POCANTICO HILLS CSD

CAPITAL IMPROVEMENTS PHASE 2

CONTRACT DOCUMENTS

SECOND FLOOR LIGHTING & FA PLAN - AREA B
 PHASE 2 CAPITAL IMPROVEMENTS
 POCANTICO HILLS CSD
 599 BEDFORD ROAD, SLEEPY HOLLOW, NY 10591
E2.3
 PROJECT NO: 3288-008

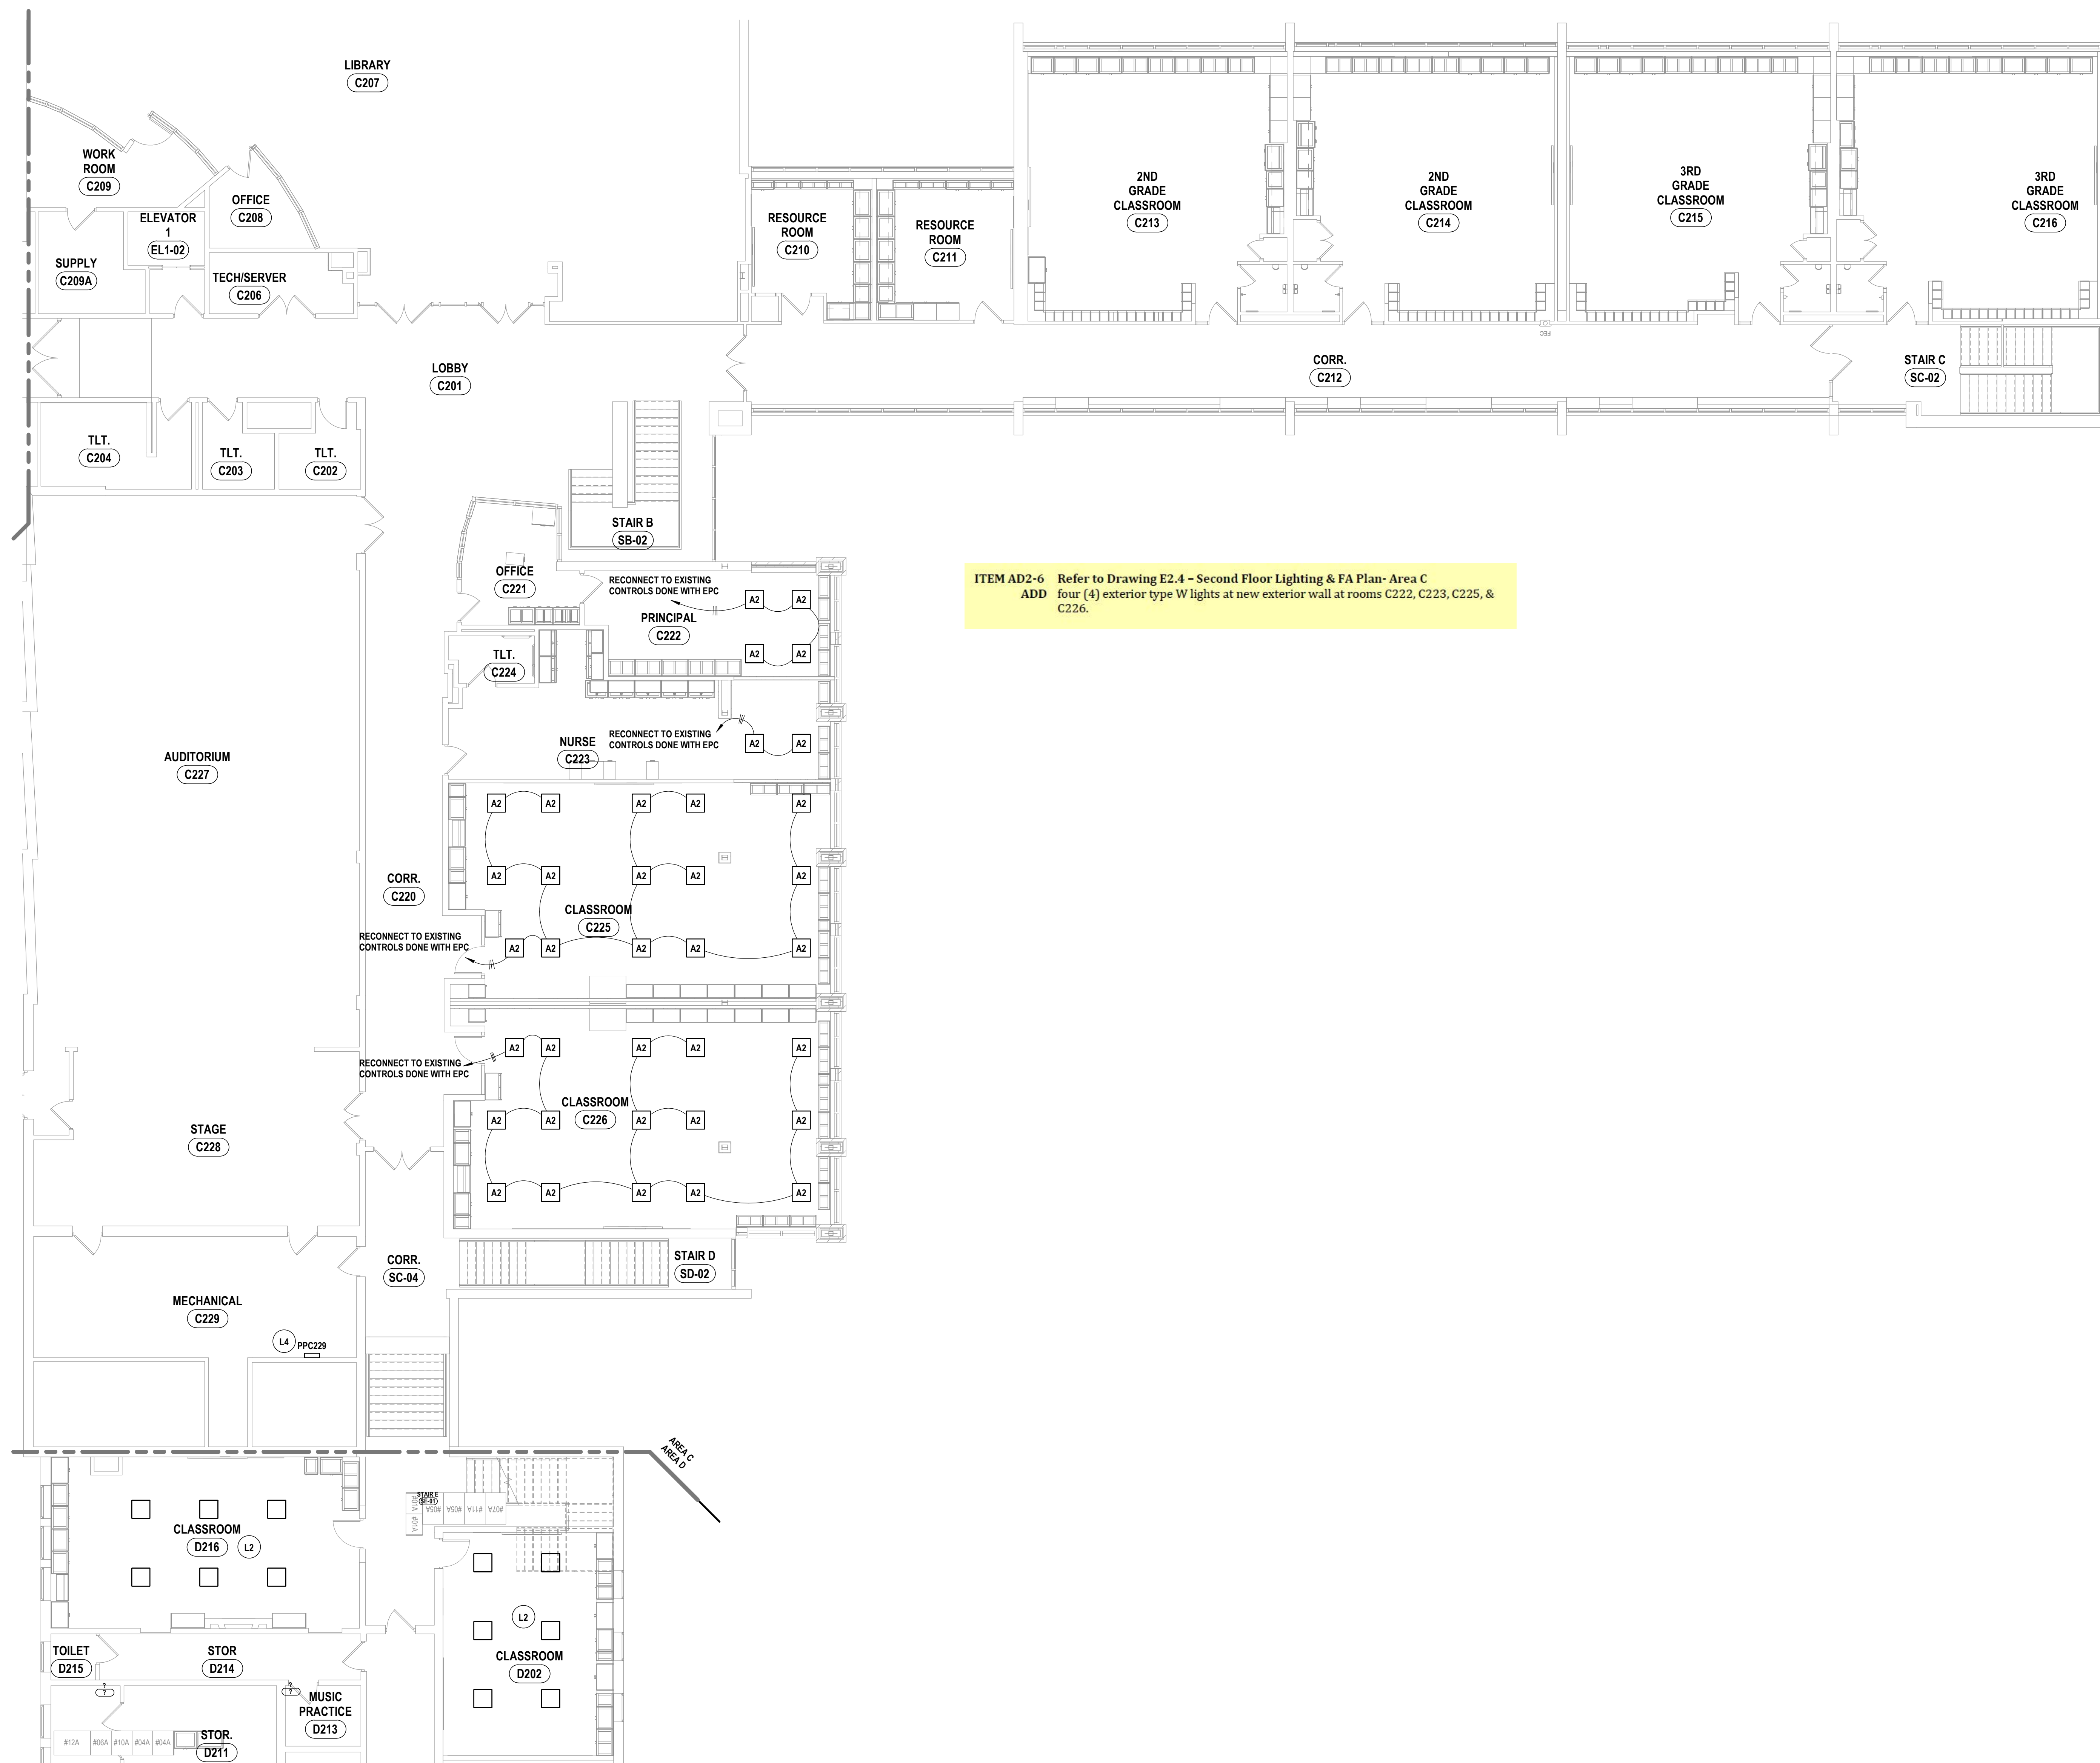
ITEM AD1-11 Refer to E2.3 - SECOND FLOOR LIGHTING & FA PLAN - AREA B
 DELETE refer to detail 1, remove any lighting, controls, and ceiling work in room Art B216.
